Office Action Summary	Application No. 10/581,193	Applicant(s) MURAKAMI ET AL.	
	Examiner JACOB KNUTSON	Art Unit 3611

2. Claims **1 – 7 and 9 are** rejected under 35 U.S.C. 103(a) as being unpatentable over **Nagamatsu et al. (US 2004/0206199 A1)**, in view of **Kodaira (US 6,427,799 B1)**.

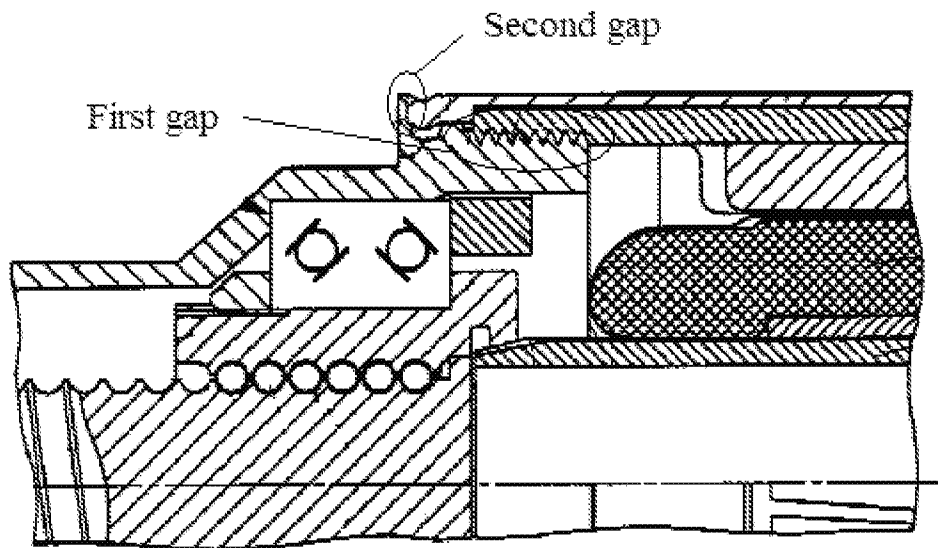
For claim 1, Nagamatsu et al. discloses a vehicle steering apparatus comprising: a housing 2 for supporting coaxially a steering shaft 1 and a rotating cylinder 51, said rotating cylinder being provided with a screw mechanism 50 52 and 53 constructed between said rotating cylinder and said steering shaft for moving in an axial direction for the purpose of steering and being rotated by a transmission from a steering motor, said housing being constructed in a separated form having of first and second housings 21 and 22, said first and second housings being fit to each other by a spigot-joint fitting on an outer side of a retaining part of a thrust bearing 54 for thrust-supporting said rotating cylinder, wherein a first gap is provided in a part that constitutes a part of the spigot-joint fitting part of said first and second housings and that is located radially outward from on an outer side of a fixing nut 56 screwed into said retaining part in order to apply a tightening force on said thrust bearing from one side, and wherein said first

Nagamatsu et al. does not disclose a second gap on a part of a spigot-joint fitting being smaller than the first gap, the retaining part has a first portion whose diameter is smaller than a diameter of a second portion thereof which secures concentricity of the first and second housing, thereby providing a first gap, and the first gap is provided adjacent to the second gap in the axial direction.

However, Kodaira discloses a first gap being larger than a second gap on a part of a spigot-joint fitting part of two housings A and B where said first gap is provided as best shown in Fig. 3. Kodaira discloses the retaining part has [a first portion, as shown in the drawing below at the location of the screwing region, whose diameter is smaller than a diameter of [a second portion] as shown below at the location with a screwing region, thereof which secures concentricity of the first and second housing, thereby providing a first gap], and the first gap is provided adjacent to the second gap in the axial direction as shown in the drawing below. The second gap being miniscule as it may be, there still exists a space or gap in between the housings.
